CITY OF CODY
PLANNING, ZONING AND ADJUSTMENT BOARD
TUESDAY, SEPTEMBER 24, 2013
CITY HALL COUNCIL CHAMBERS @ 12:00 NOON

AGENDA

**CITY OF CODY
PLANNING, ZONING AND ADJUSTMENT BOARD
STAFF REPORT**

**CITY OF CODY
PLANNING, ZONING AND ADJUSTMENT BOARD
STAFF REPORT**

DATE: 8/16/2013
PROJECT #: 13-48
DRAWN BY: GVIII
SHEET TITLE:
SITE PLAN
SHEET NUMBER
C1.0

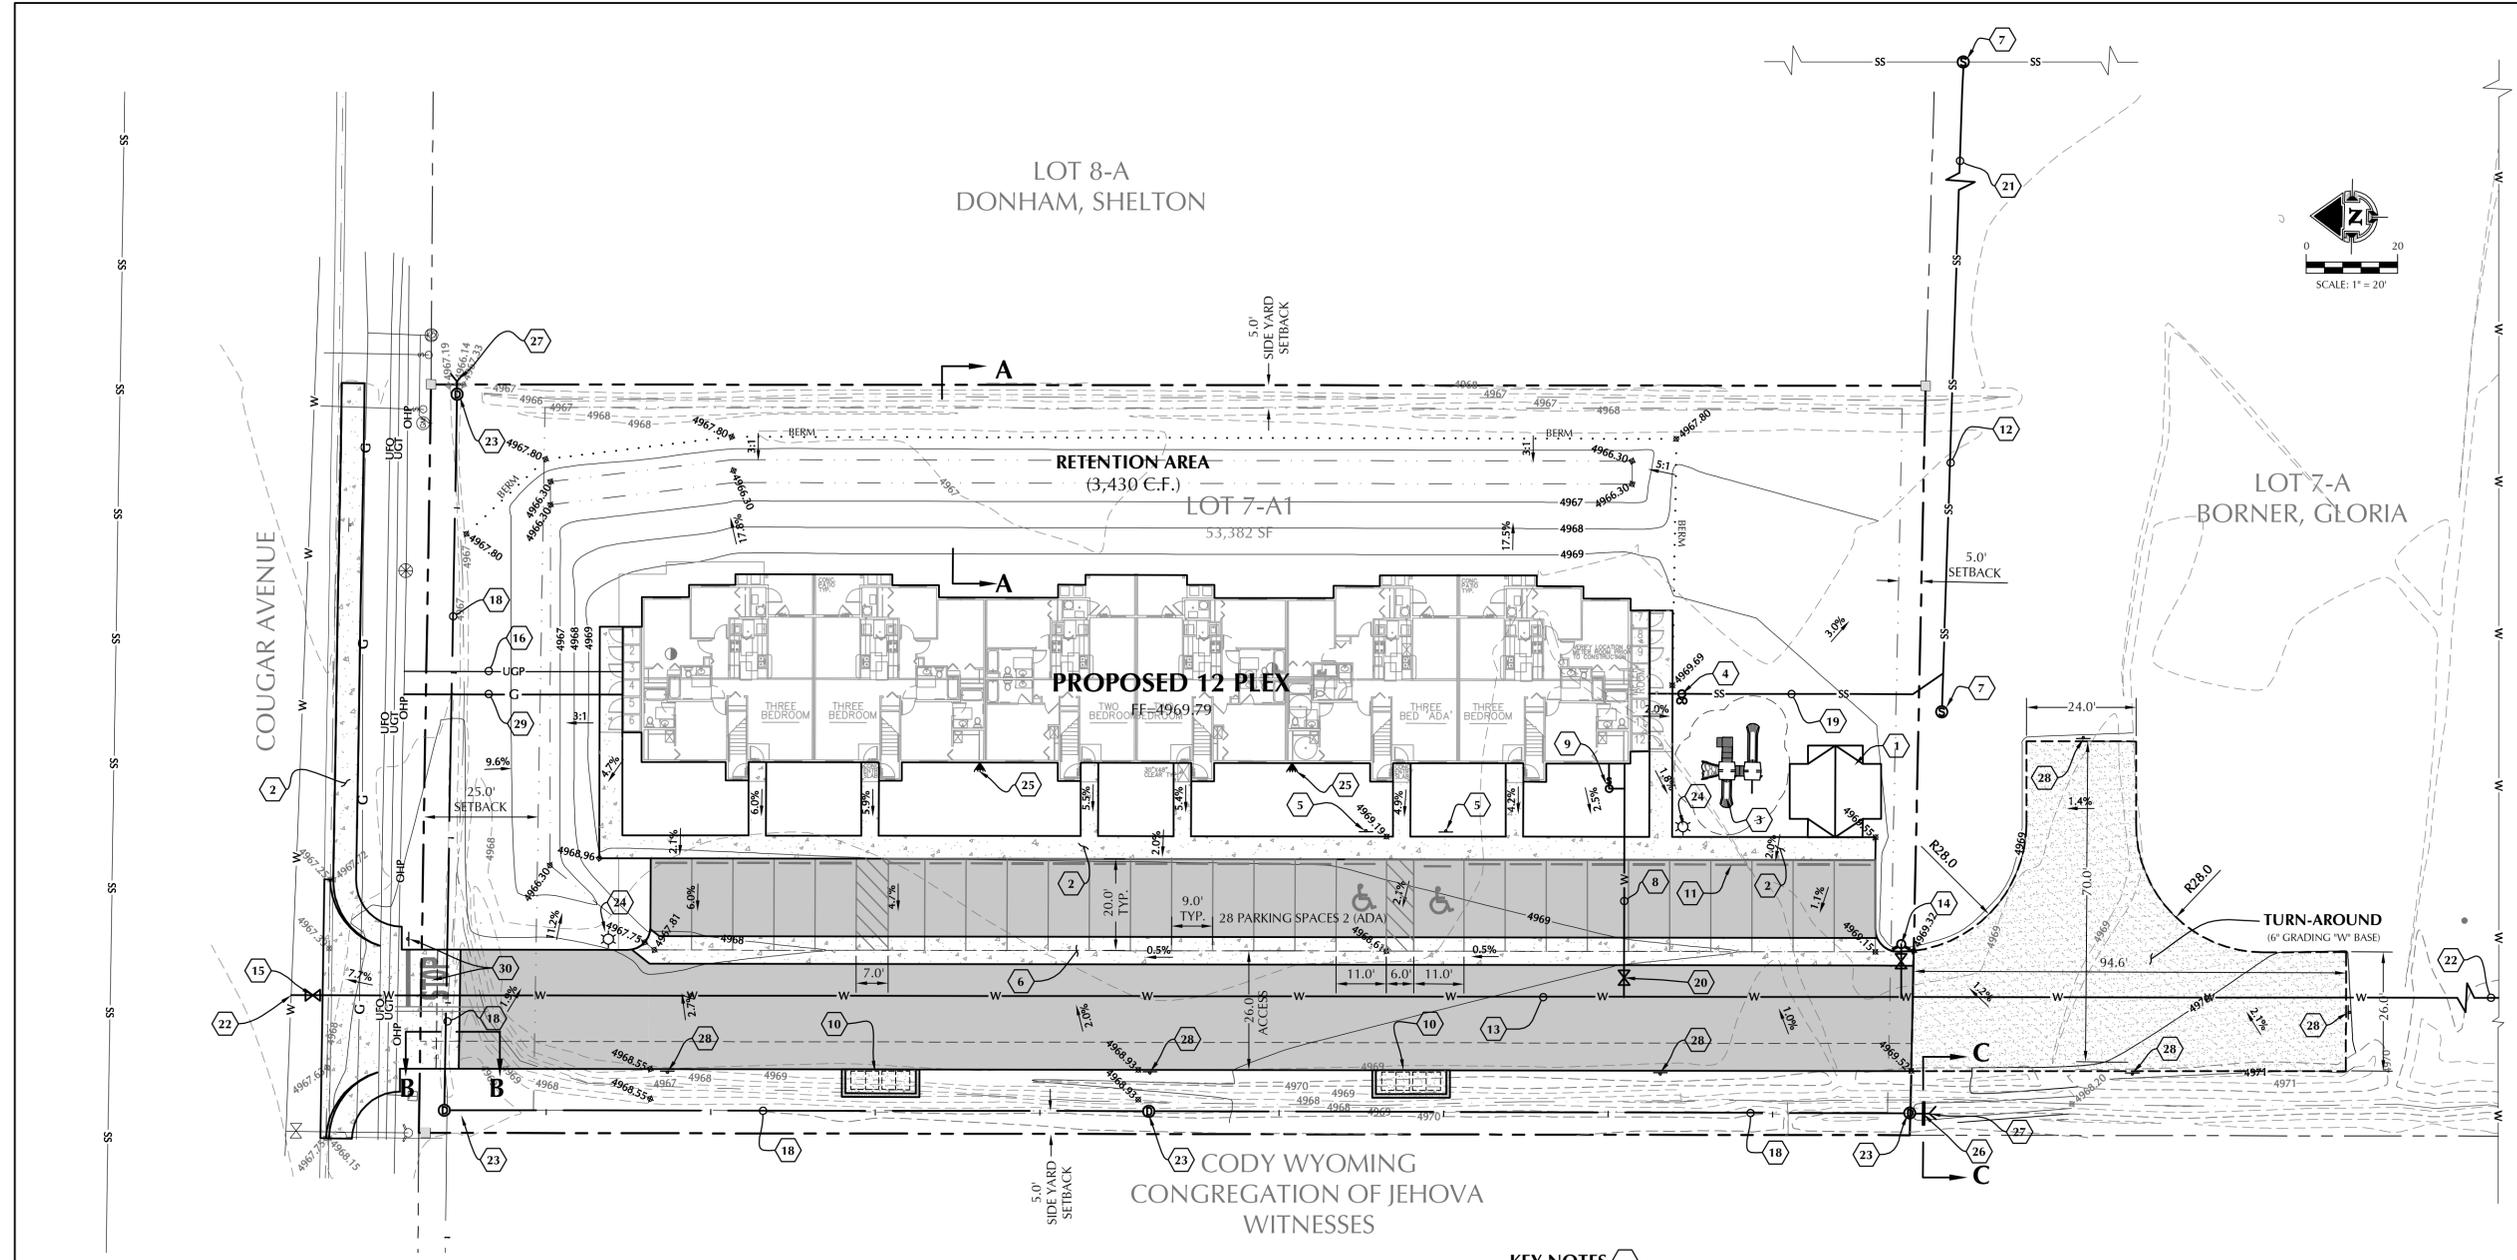
5. In addition to the standard submittal requirements for the final plat, it is specifically required that the final plat application include:
 - a. Engineered designs for the 26-foot wide, paved interior roadway.
Status: Plans were provided with the apartment site plan. That site plan is attached for your reference.

J & K MAJOR SUBDIVISION

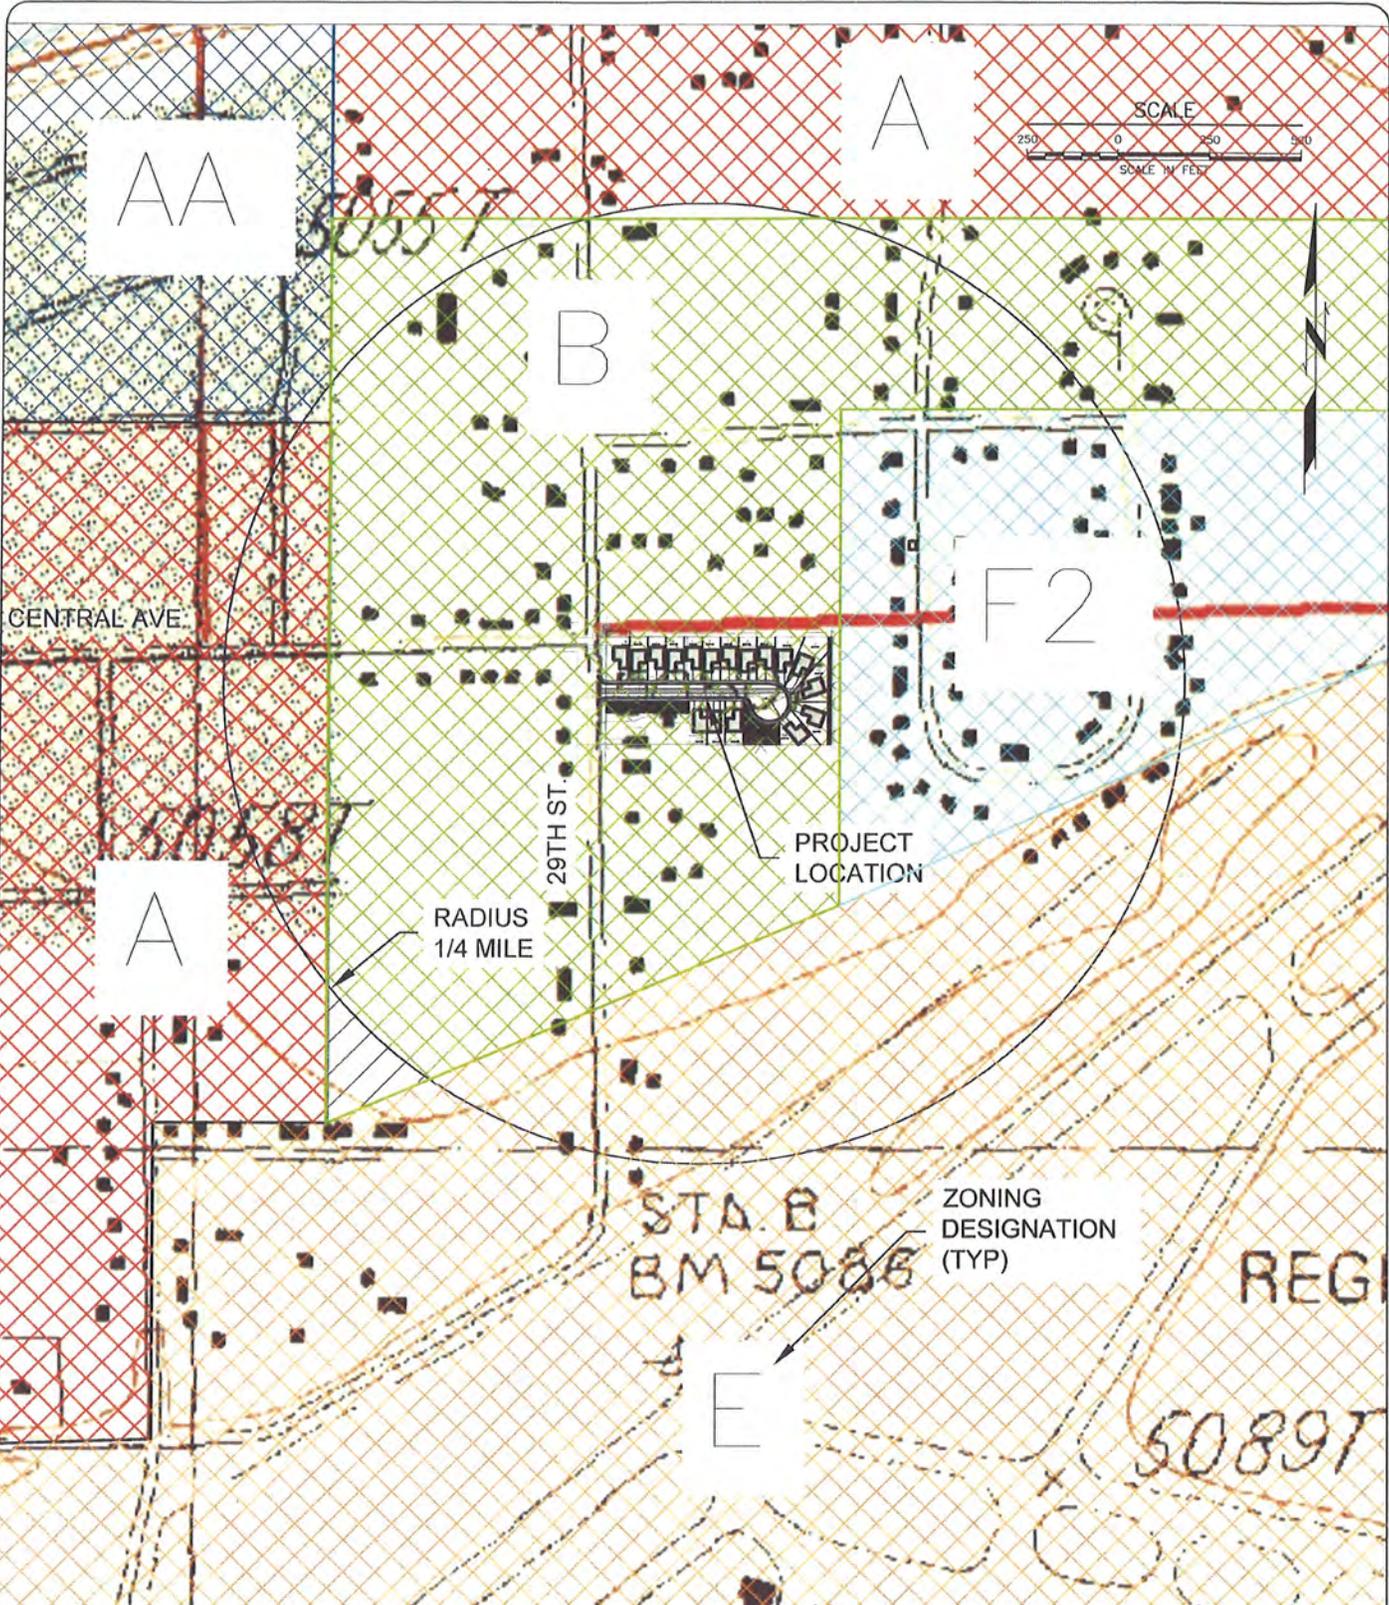
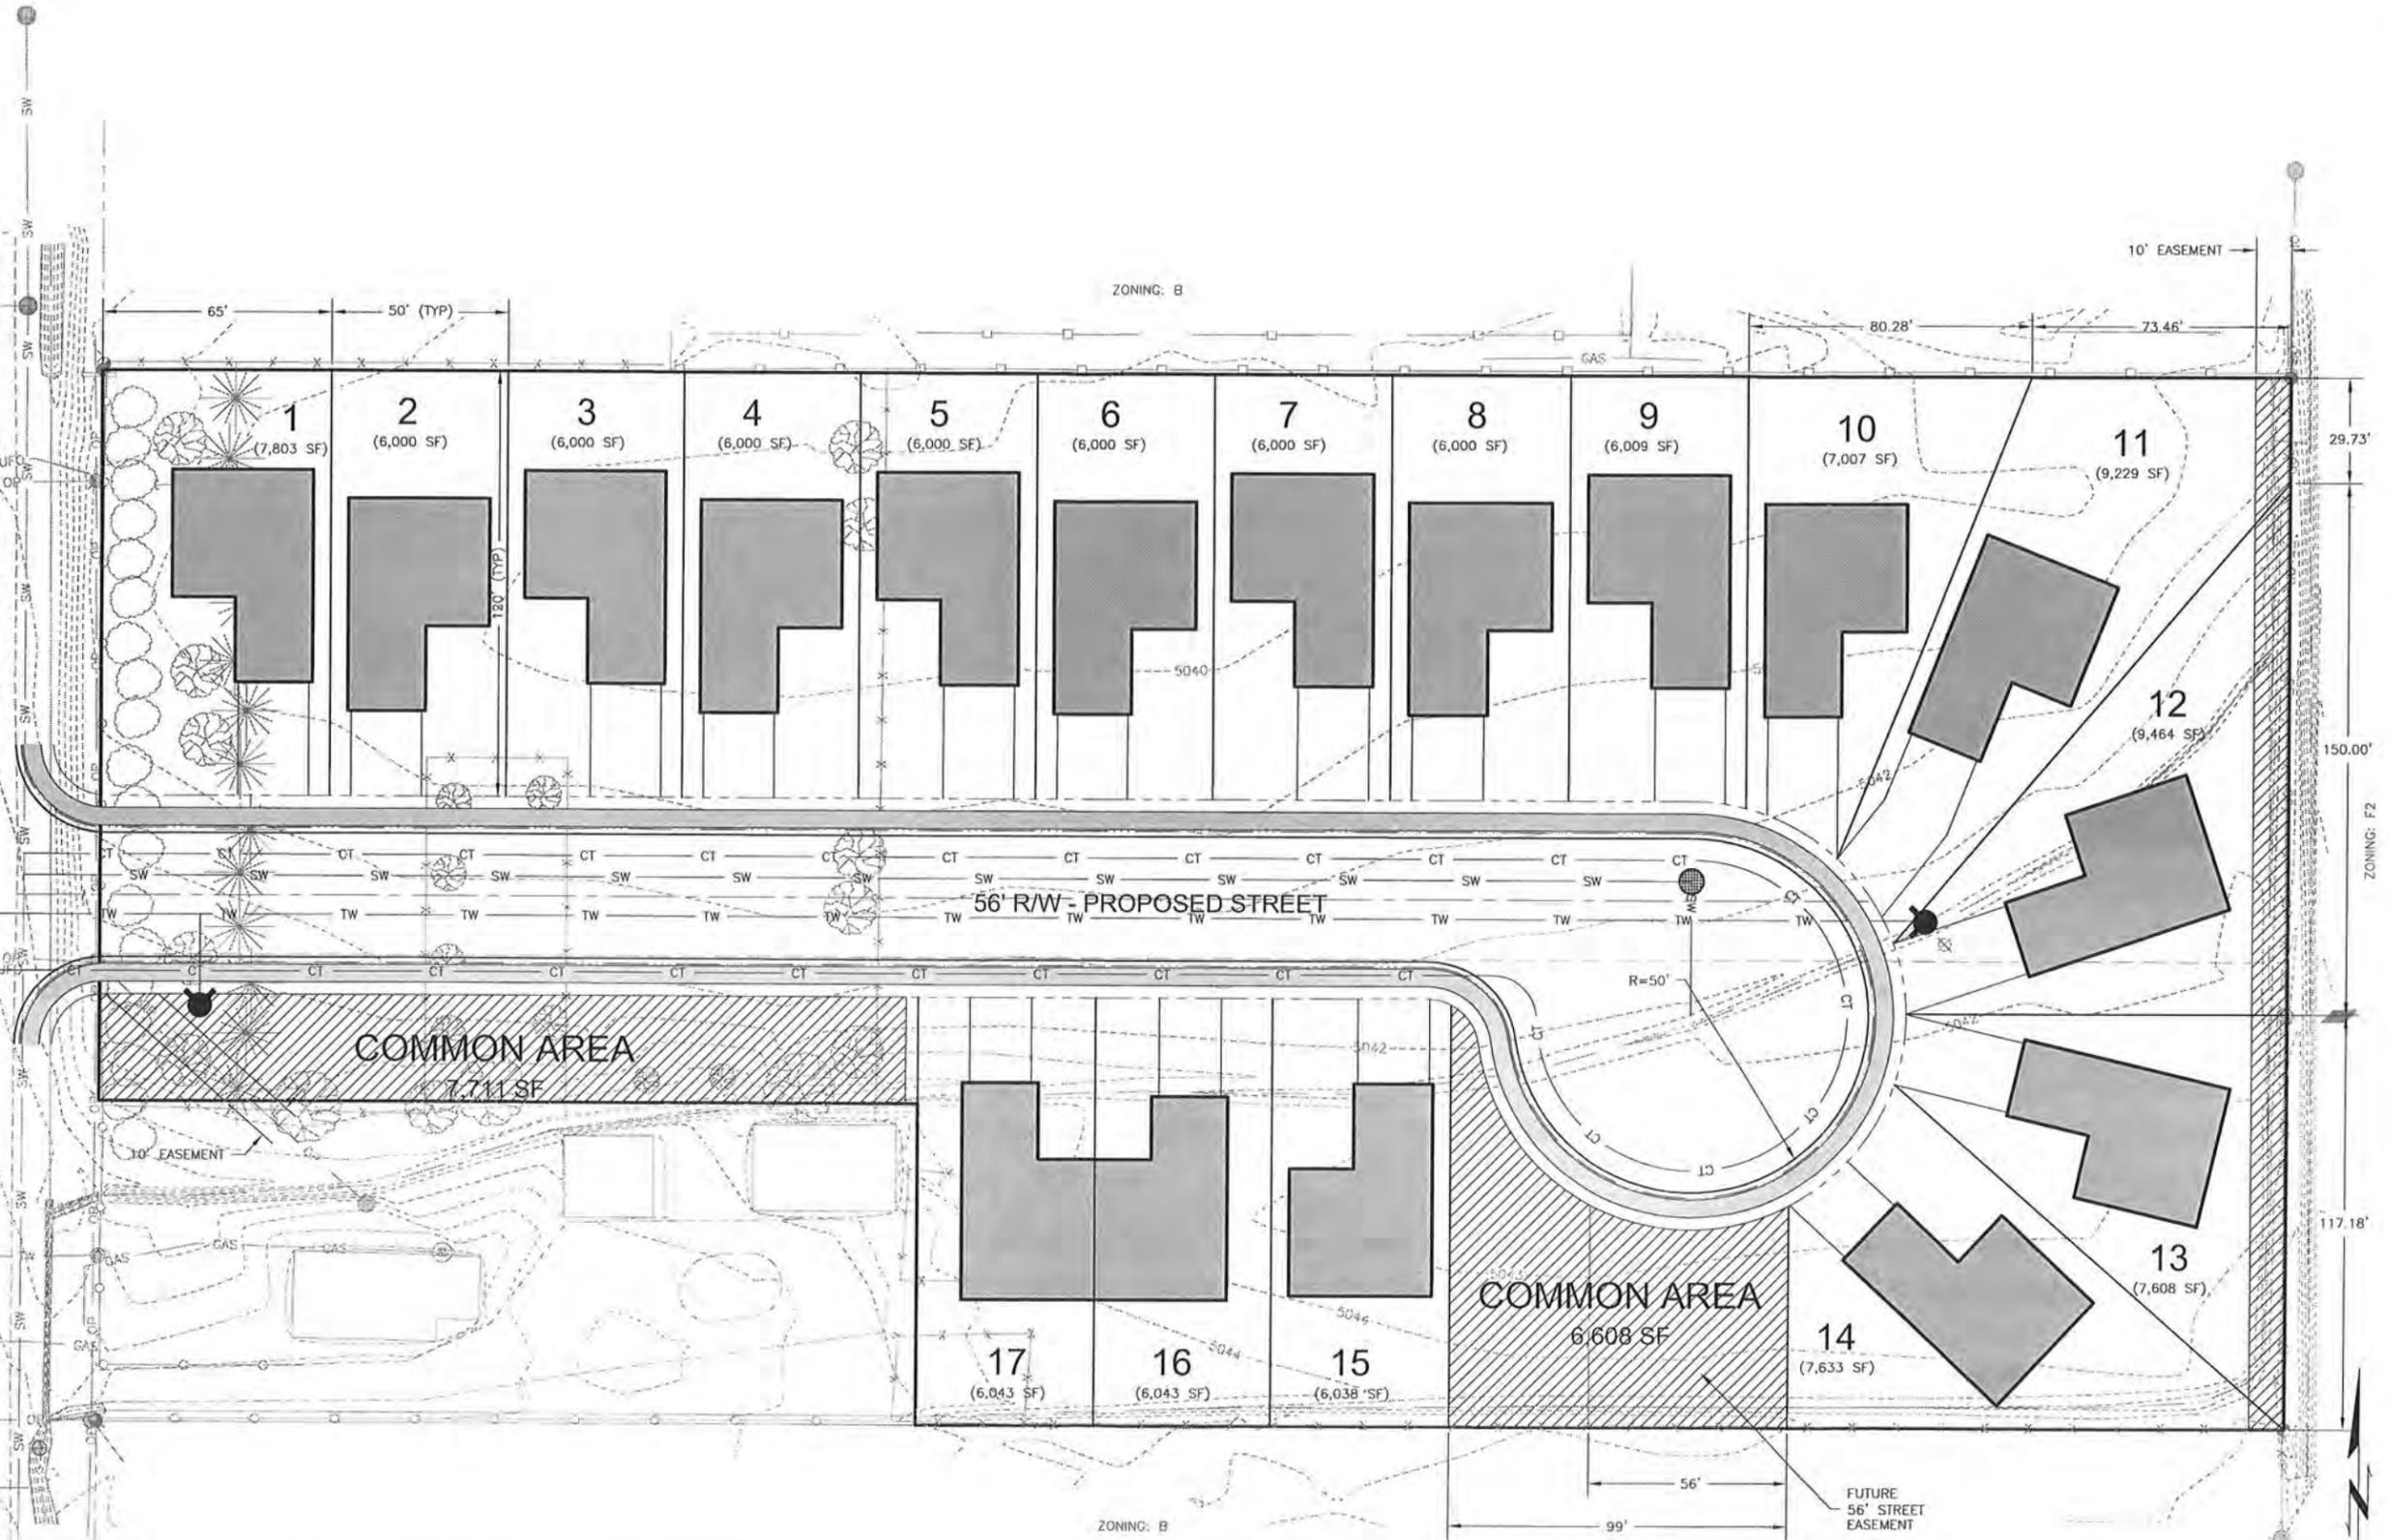
There are overhead power lines along the east and west sides of the property. Electrical service for this layout will involve relocation of a pole in alignment with the proposed street. The power line will drop from the new pole and run along the north side of the street, around the cul-de-sac, through the common area to the south side of the plat and over to the power line on the east property line to provide a looped system.

One requested modification to the plat would be to place the common trench (electrical, telecommunications, cable) behind the sidewalk, rather than under the asphalt. This would necessitate a utility easement for the lines, transformers, and utility boxes. An 8-foot wide utility easement along the street is expected to be sufficient.

The proposed street cross-section is similar but not an exact match to the local street standard in the draft master plan. The proposed section is about two feet wider from back of curb to back of curb than shown in the draft master plan. The proposed cross-section is five feet narrower than the local street cross section in the 1997 Master Plan. Also, the right-of-way width is 56 feet in width to match the draft master plan (60' in the 1997 plan). Although the new master plan is not yet adopted, the narrower street width is adequate for the situation and can be considered through the subdivision variance process.

Streetlights will need to be added to the plans. Their location needs to be coordinated with the electrical superintendent.

The location and design of a central mailbox needs to be coordinated with the post office and reflected on the street plans, as it can affect sidewalk location and influence streetlight location.

One option would be to combine the Lots 9 and 10, 11 and 12, and 13 and 14, to provide duplex lots, which would meet the code requirement. Another option would be to pursue a subdivision variance. The third option would be to otherwise reconfigure the lots to meet the standard (would likely lose two lots, but need not lose density).
